M E M O R A N D U M

March 3, 2016

TO: Planning, Housing, and Economic Development (PHED) Committee
FROM: ^{MM} Marlene Michaelson, Senior Legislative Analyst
SUBJECT: Westbard Sector Plan

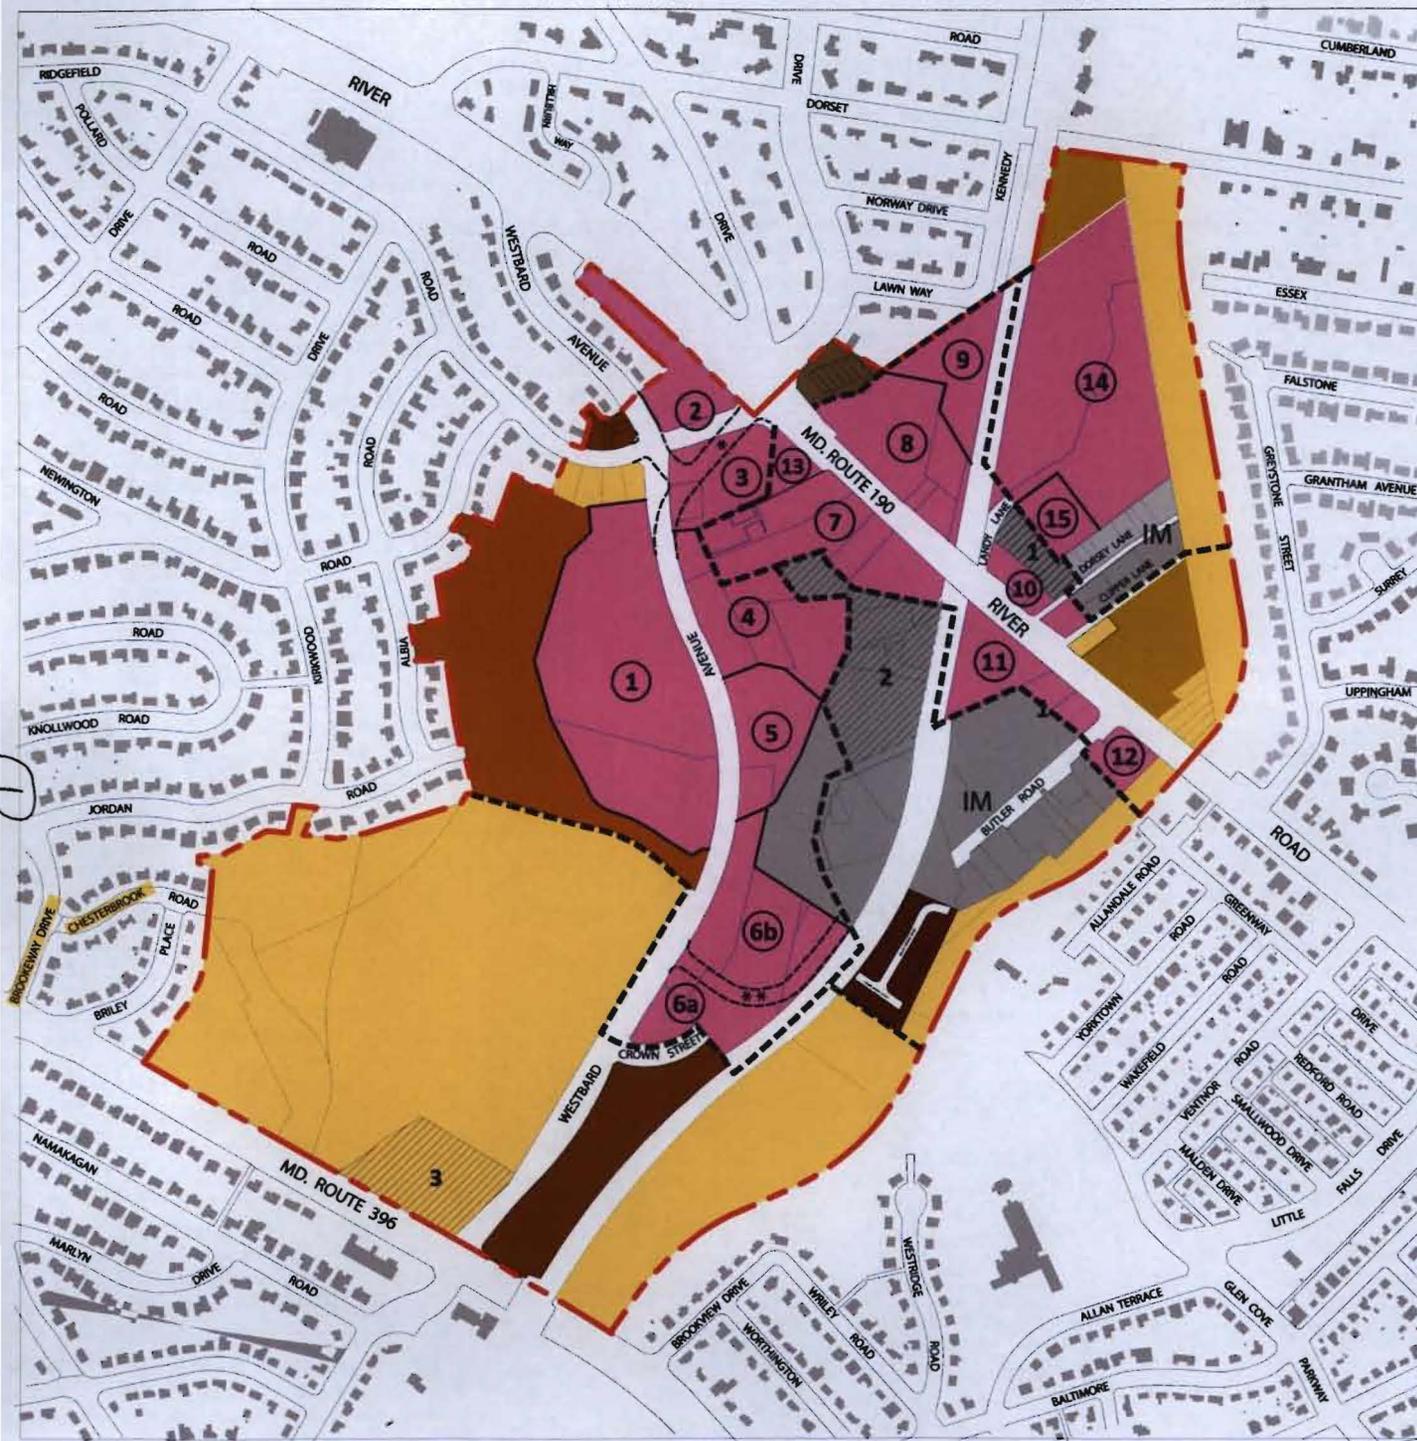
The Plan specifically recommends that the Park Bethesda site in the Westbard Avenue District (site 6a and 6b in the maps on © 1 and on page 63 of the Sector Plan) have increased affordable housing.

The South River District is discussed on pages 78-81 of the Sector Plan. Specific sites are not identified on the map on © 1 since the Sector Plan recommends confirming the existing zoning (see page 79 in the Sector Plan); however, it also recommends adding a floating zone recommendation for CRT 3.0, C0.5, R 2.75, H-75 for property that is currently zoned Moderate Industrial (IM) and has auto-repair shops. The Sector Plan discusses the importance of the industrial district’s economic

Figure D.7: Westbard Parks Recommendations Initial Phase Area Map

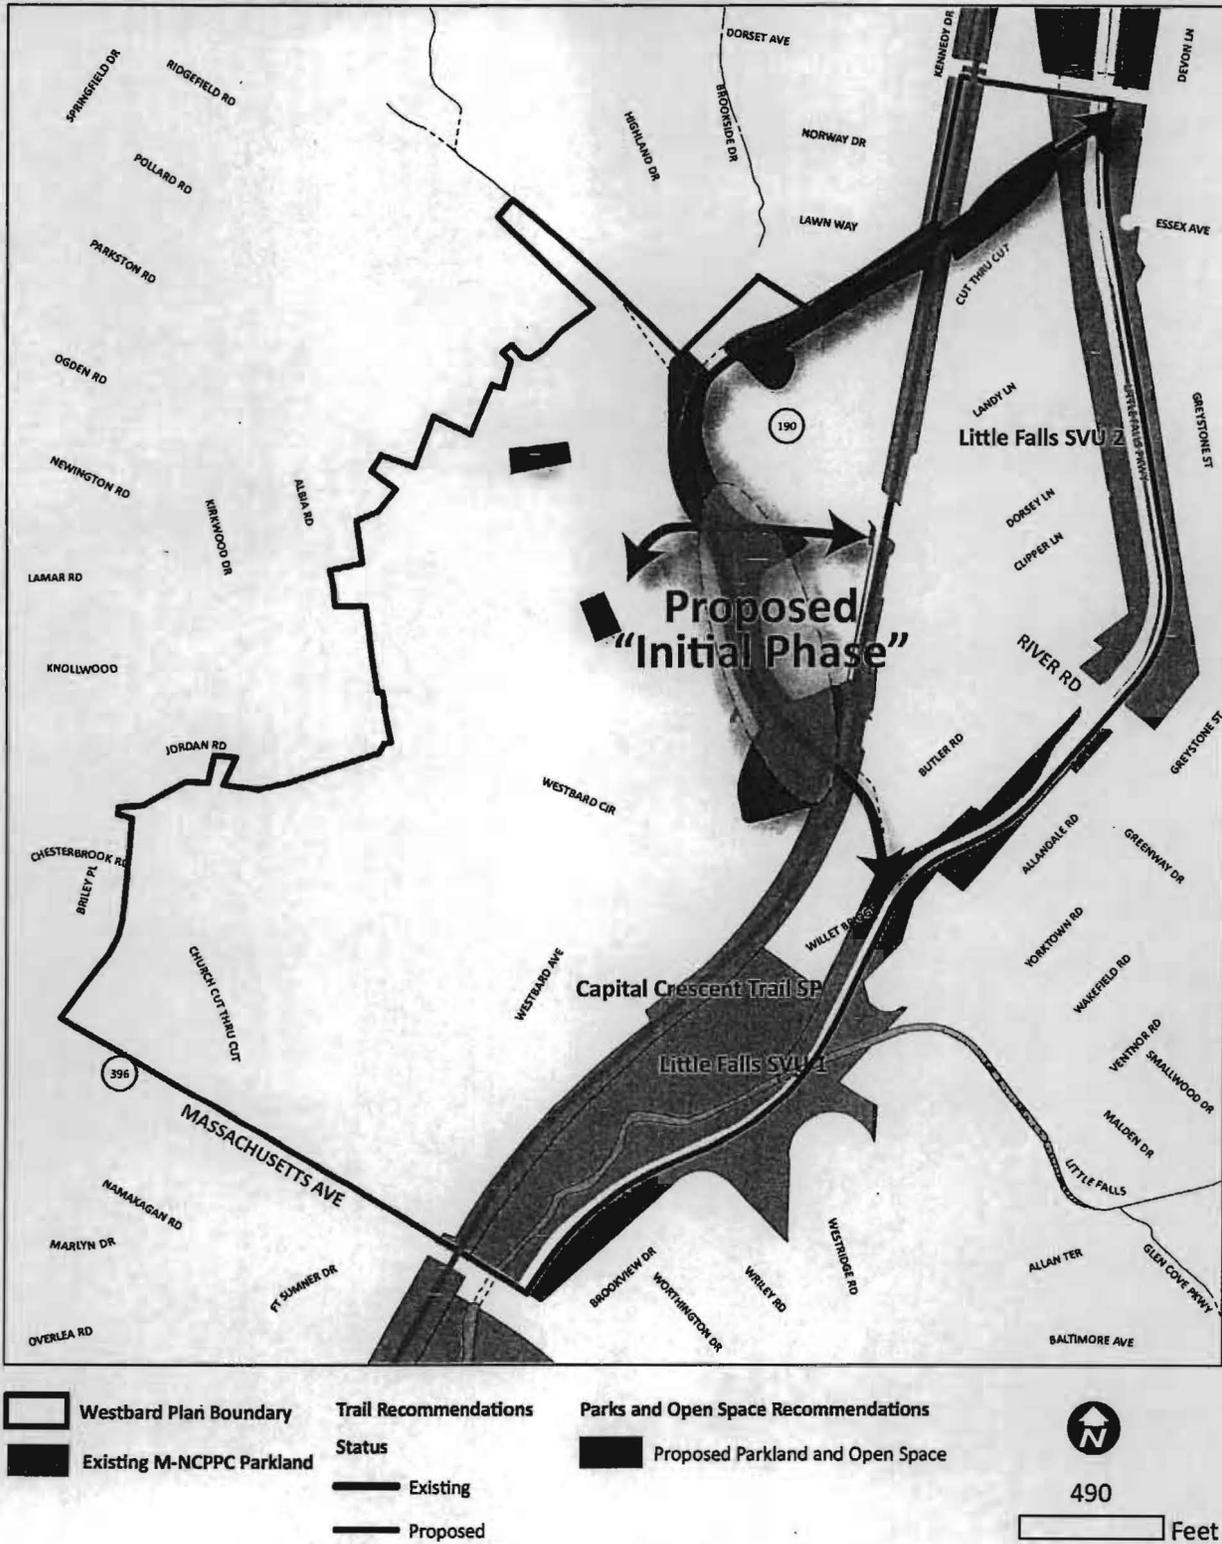
The portion of the project that Staff believes should constitute Phase 1 is shown as the "Proposed Initial Phase" on a map on page 101 of the Sector Plan Appendix and attached on © 6. Phase 2 would include portions of the park associated with development that is likely to occur in the relatively near term (area C on the map on page 107 of the Sector Plan Appendix and attached on © 7). The portion Staff has identified as Phase 3 includes those portions of the park associated with **longer-term**

Staff recommends that the Council ask the Planning Board to prepare a more detailed phasing plan, identifying which portions of the Greenway can be expedited with public funding. Staff further recommends that the PHED Committee schedule a meeting this summer to discuss M-NCPPC priorities for acquisition and where acquisition of portions of the Willett Branch Greenway fit within the list of priorities. Staff believes that plans should be made to acquire necessary parcels as soon as possible, but that determination cannot be made without considering whether it would divert money from other equally or more important acquisitions. Facility Planning should be scheduled immediately following acquisition.

Figure D.10: Westbard Parks Recommendations Long-term Phase Area Map

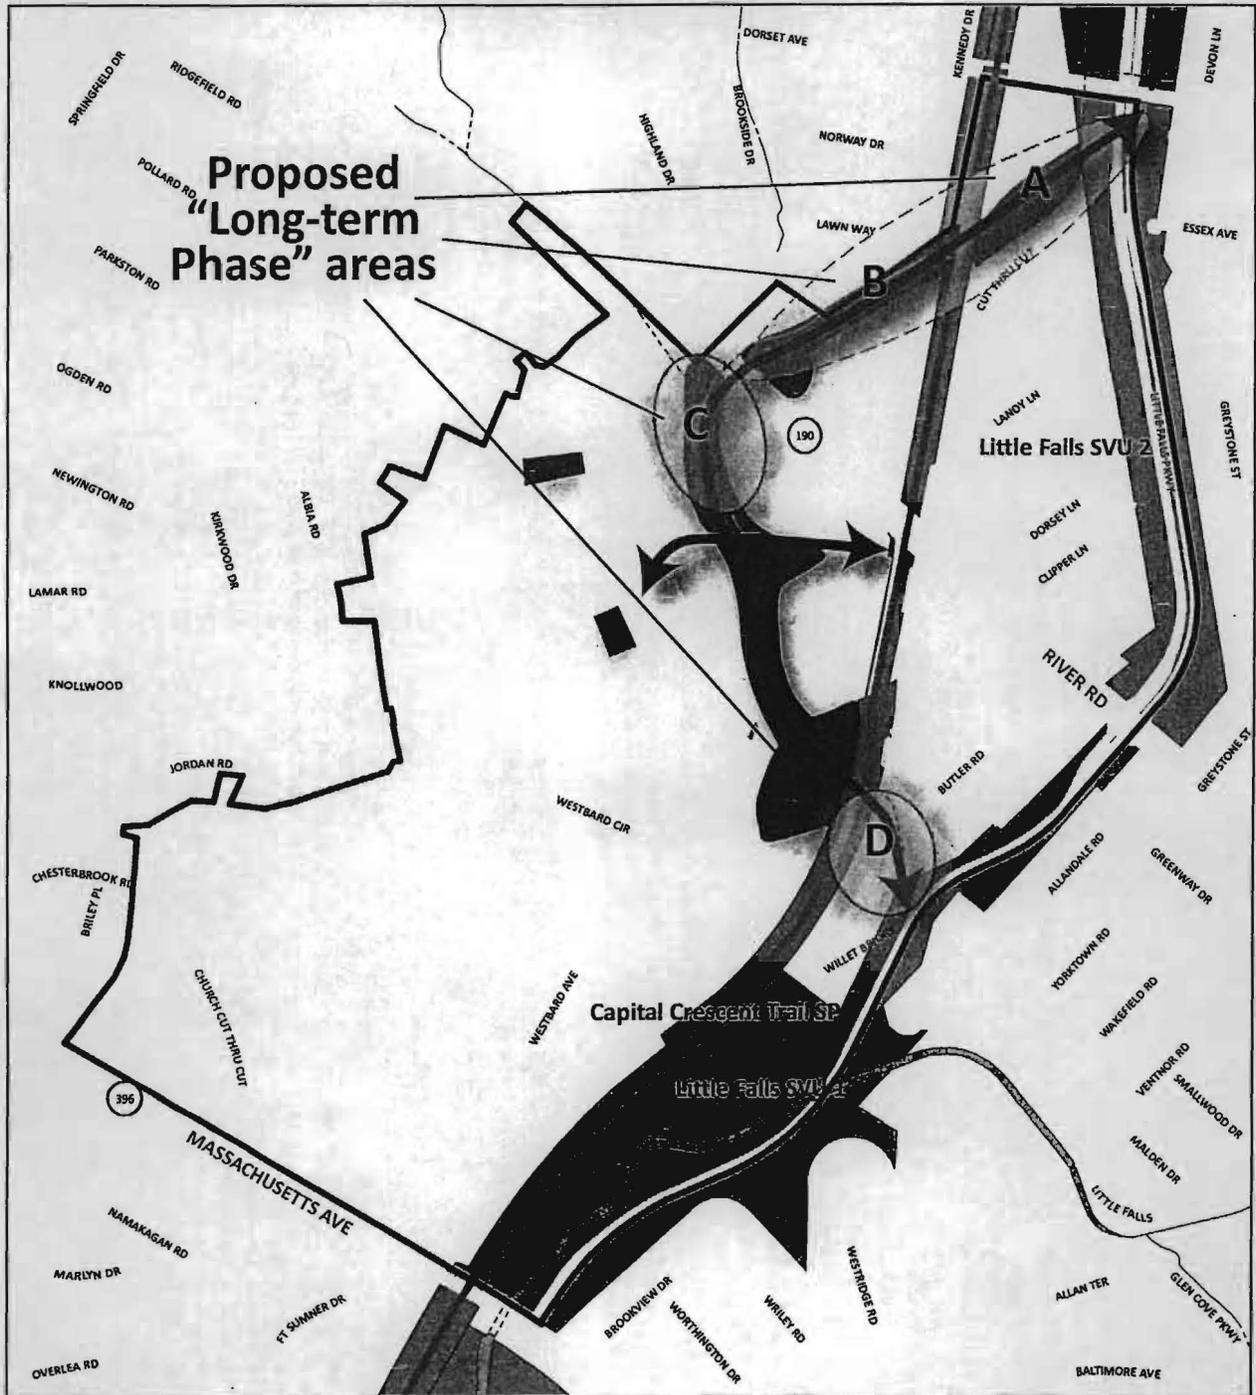
development likely to occur beyond the time horizon of this Plan (e.g., daylighting of portions of the stream on the Washington Episcopal School (WES) property.) These areas are shown as areas A, B, and D on the map on © 7. County funding for acquisition and development could be considered at a later date if these properties do not redevelop.
